GW - 244

**RE: Inspection Report Follow-up, GW-244
Chevron USA Inc. Lateral #4 Compressor Station
Rio Arriba County, New Mexico**

**Re: Inspection Report, GW-244
Chevron, Lateral # 4 Compressor Station
Rio Arriba County, New Mexico**

OCD Inspection Chevron Lat # 4, GW - 244

Photo 1 NW Corner of Lat. 4.

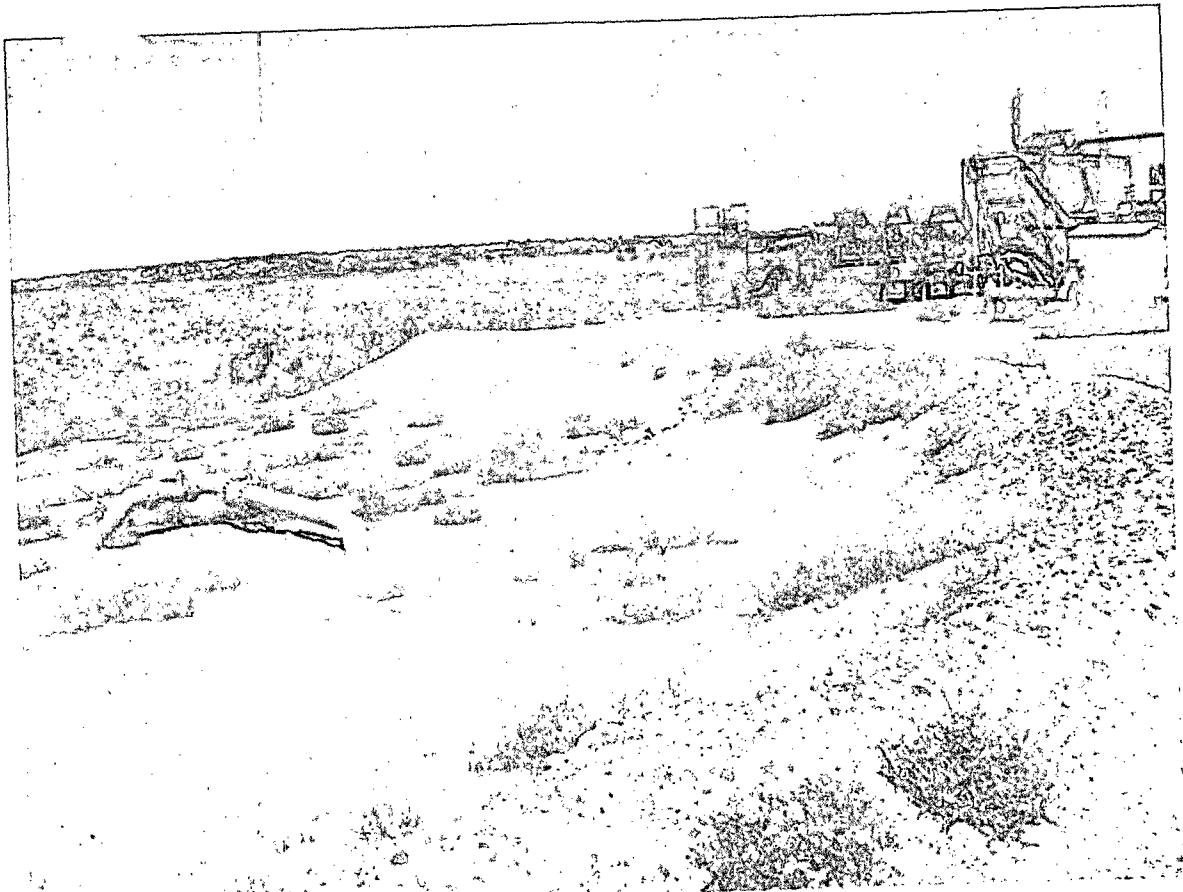
On April 21, 2008 during the inspection of our Lateral 4 Compressor Station which is covered under GW-244 discharge permit, you requested that the facility be bermed to decrease run on and off of water. The northwest corner of the lateral 4 area is much lower than the other elevated parts of the facility making it difficult to berm; therefore we'd like to install the berm as shown in the attached schematic. As you can see in the attached photos, there are not any below or above grounds tanks or other large pieces of equipment with fluids that would potentially result in any contamination in this area of the facility. Pictured in the area are gas pipelines. We believe the proposed berm configuration would still meet the objective of decreasing water run on and off from the area that has potential pollutants.

Approved.

Photo 1: Below -grade tank has been removed.

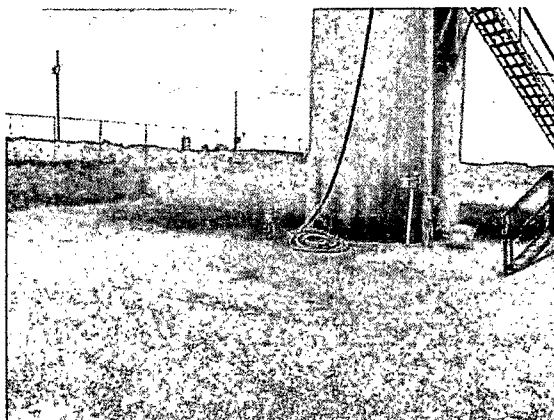
1. Photo 1 – 3: Below-grade tank has liquids in its leak detection system. The tank is on Chevron permitted property and is therefore liable for the tank. Chevron shall verify the integrity of the tank. If there was a breach in the secondary detection system then Chevron shall submit to the OCD a plan of action for clean up this tank. Chevron has **six months** to comply with this issue.

Photo 4: Cap for leak detection system is in place.

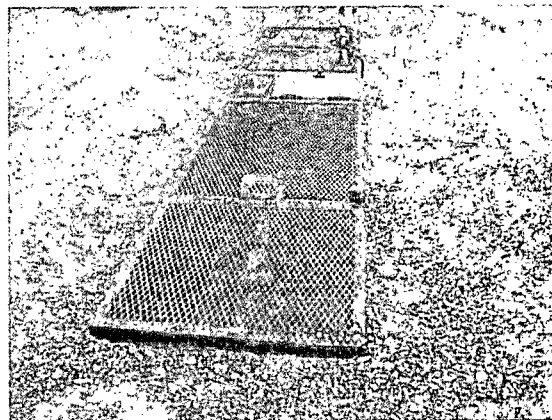
4. Photo 8 – 10: The caps for these below-grade tank sumps are not in place. Chevron shall ensure that facility personnel inspect these areas when on site and maintain a log of these inspections. Keep caps in place when not being inspected.

Photo 2: Condensate tank has been labeled.

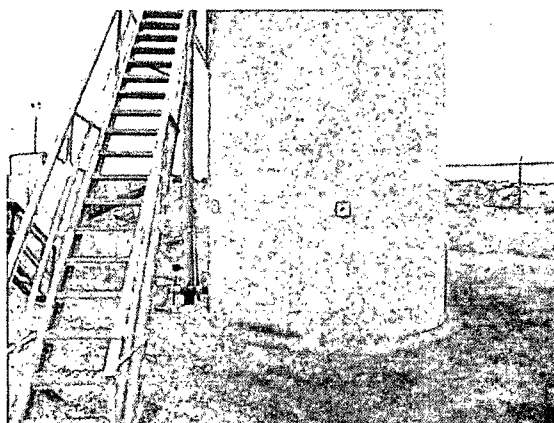
2. Photo 4 – 5: Label the condensate tank. Chevron has **three months** to resolve this issue.
3. Photo 7: Saddle tank hose extrudes beyond the secondary catch containment area. Chevron shall reconfigure this within **three months**.

Photo 7: Replaced oil tank.

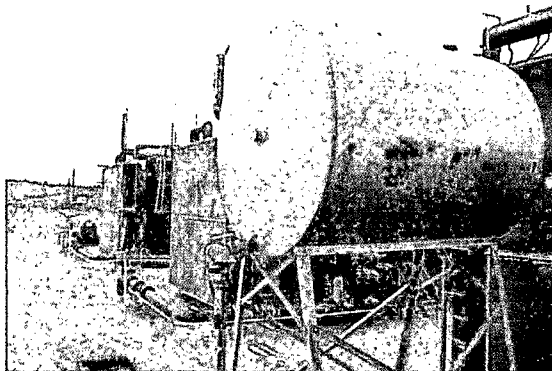
Image 6: Lube tank is bulged.

6.	Berm the facility to decrease run on and off of water. This will prevent erosion; the possibility of any spills or releases from going off site and creating excess waste from run on commingling with liquids on site.	Berm is currently being added. Photos will be provided upon completion.
	Bulging Lube Tank (Photo 6 in inspection report)	<u>Photo 7:</u> Tank has been replaced.
